H401/H601

**Power Factor and Snubber Capacitor
Removal**

Field Service Bulletin
(P/N 804430)

Revision 0 – March, 2002

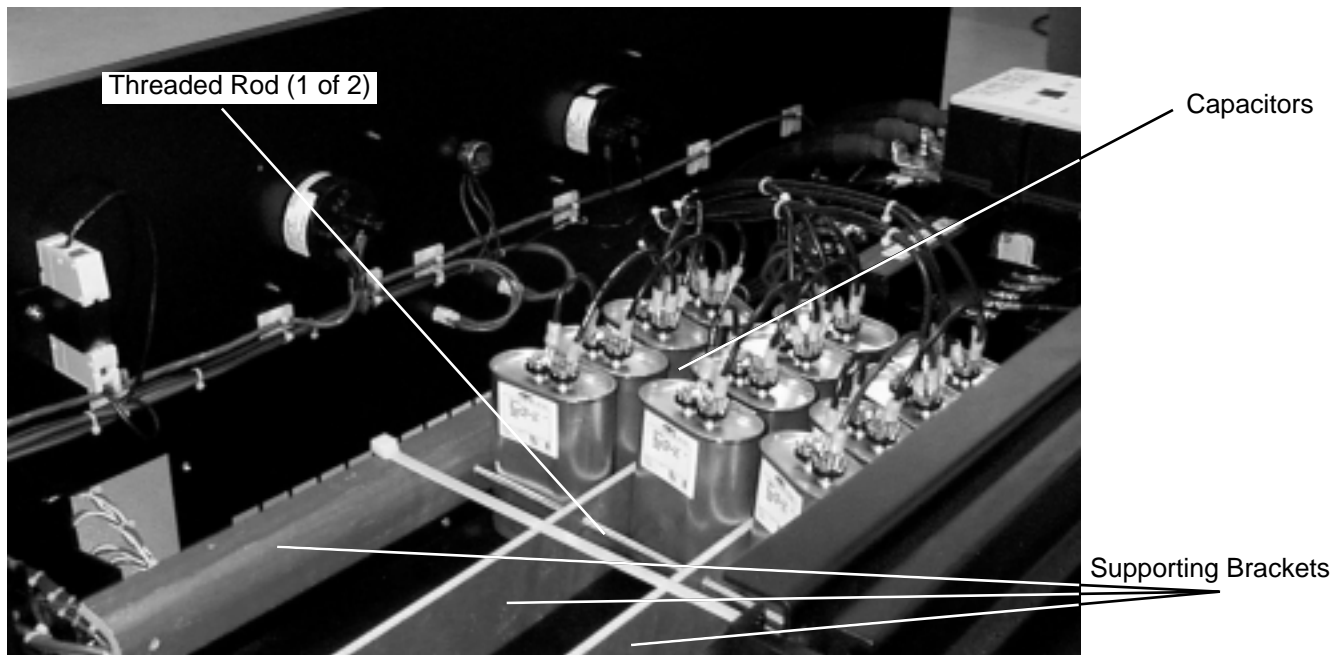
- 1 – Disconnect power from H401/H601.
- 2 – Remove top cover of power supply and locate the main contactor (1C). Remove the 12 ga. wires from the secondary side of 1C numbered 1L1, 1L2, and 1L3 (there are four at each location). See figure below.

- 3 – Loosen and remove the threaded rods at both ends of the capacitor banks. See figure below.
- 4 – Remove capacitors and supporting brackets from the machine.
- 5 – Replace top cover and turn power back on.

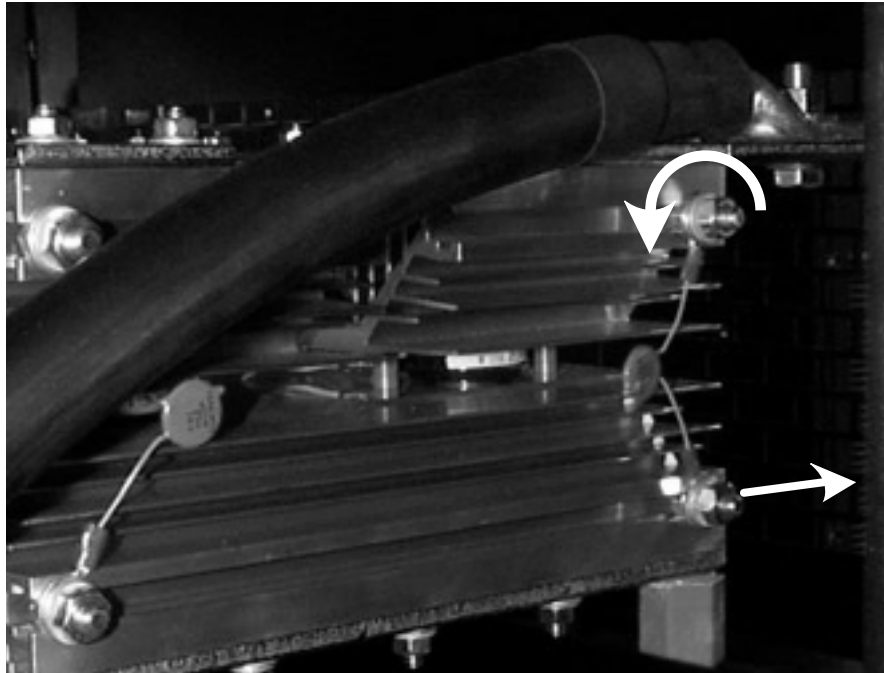
There are 6 snubber capacitors to remove from the SCR bridge.

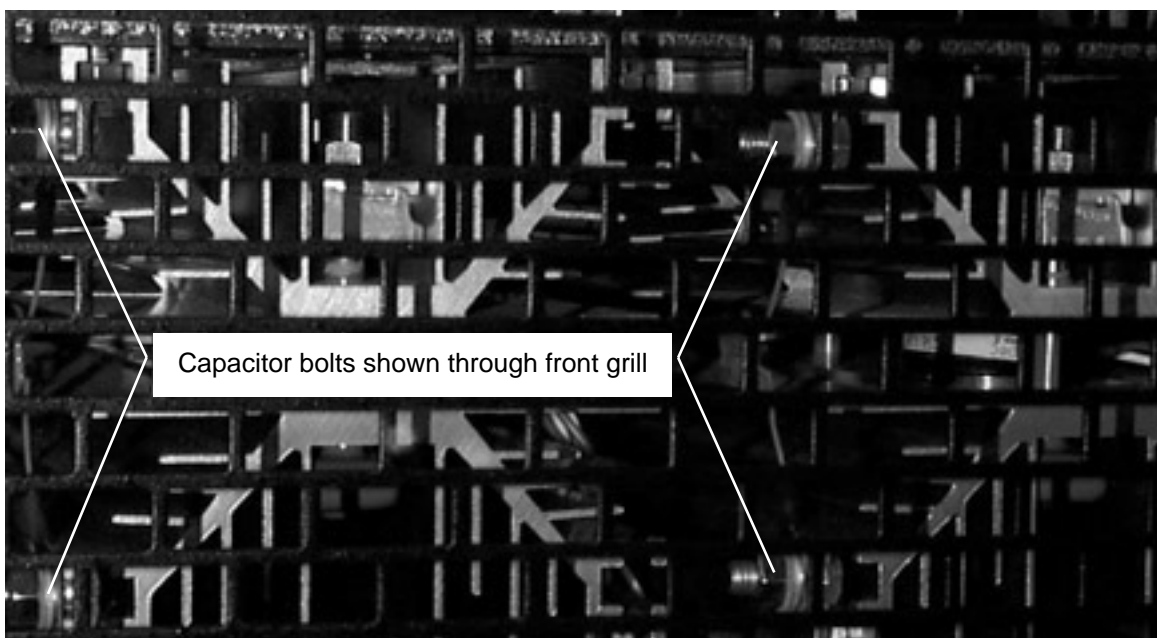
- 1 – Disconnect power from H401/H601.
- 2 – Remove left side panel.
- 3 – Loosen nuts (2) for each capacitor and slide bolt out of slot. See figure below.

Note: The 2 capacitors at the front of the machine are difficult to reach. Reach in through left side of power supply, underneath SCR bridge. DO NOT cut wires to capacitor and leave bolts in place.
